**LETTER OF VIOLATION - Inspection**

BISON STATE No.001				L-32-18S-33E	30-025-31583-00-00		
Inspection Date	Type Inspection	Inspector	Violation?	*Significant Non-Compliance?	Corrective Action Due By:	Inspection No.	
10/29/2012	Plugged Well Surface Restor	Maxey Brown	Yes	No	12/1/2013	iMGB1230424858	
Comments on Inspection:		DO NOT RELEASE. RULE 19.15.25.10. THE FOLLOWING ITEMS MUST BE CORRECTED BEFORE THE LOCATION CAN BE RELEASE: NEED TO REMOVE MAIN ELECTRICAL DISCONNECT FROM ELEC POLE, REMOVE 3 SECONDARY ELEC POLES AND WIRE, IF OPERATOR OWNED OR PROVIDE LETTER OF POWER COMPANY BEING NOTIFIED TO REMOVE, REMOVE SIGN, REMOVE 2" POLY LINES FROM ROADWAY AND CLEANUP OIL SPILLED ON THE GROUND, REMOVE JUNK AND MISC TRASH SCATTERED AROUND LOCATION. MARKER INFORMATION IS CORRECT. THIS IS 1ST LETTER OF NON-COMPLIANCE. MGB.

BISON STATE No.002				K-32-18S-33E	30-025-31697-00-00		
Inspection Date	Type Inspection	Inspector	Violation?	*Significant Non-Compliance?	Corrective Action Due By:	Inspection No.	
10/29/2012	Plugged Well Surface Restor	Maxey Brown	Yes	No	12/1/2013	iMGB1230425382	
Comments on Inspection:		DO NOT RELEASE. RULE 19.15.26.10. THE FOLLOWING MUST BE CORRECTED BEFORE THE WELL CA

BISON STATE # 2

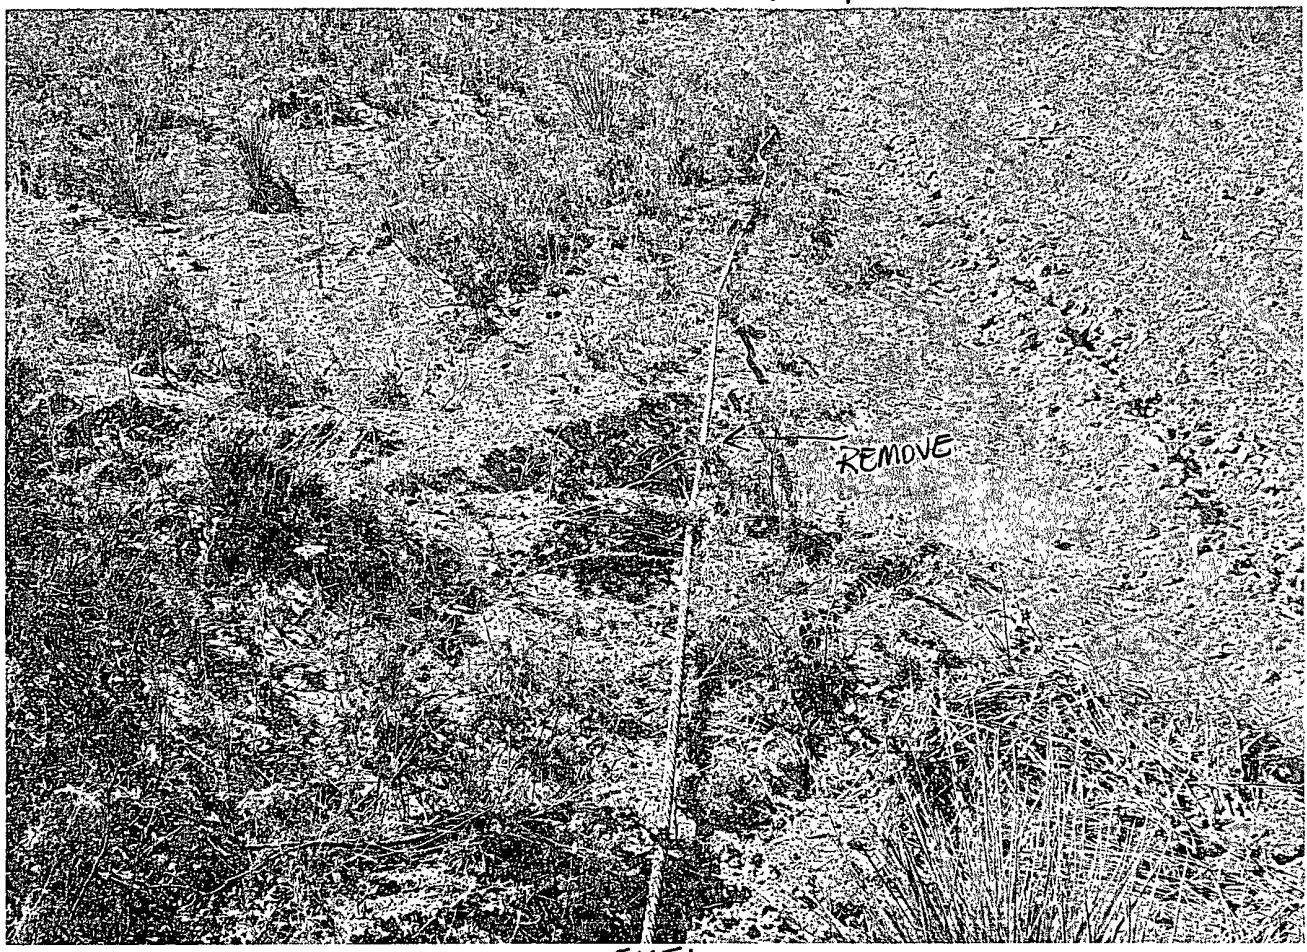
MAIN DISCONNECT  
CONDUIT, METER BASE

CHI BISON STATE # 2

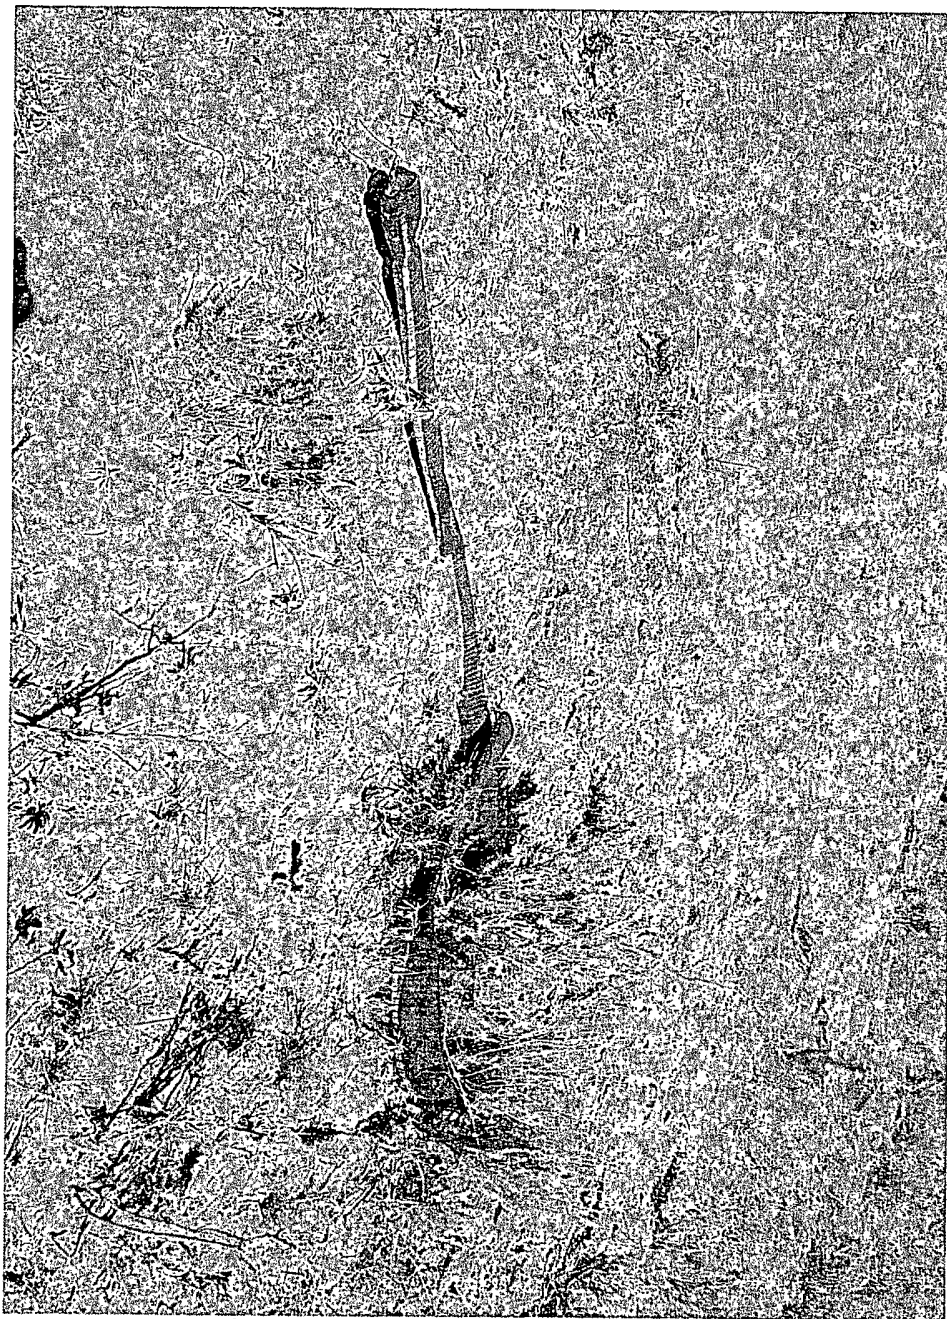
5" WIRE ROPE

REMOVE

BISON STATE #1  
MISC. JUNK & TRASH
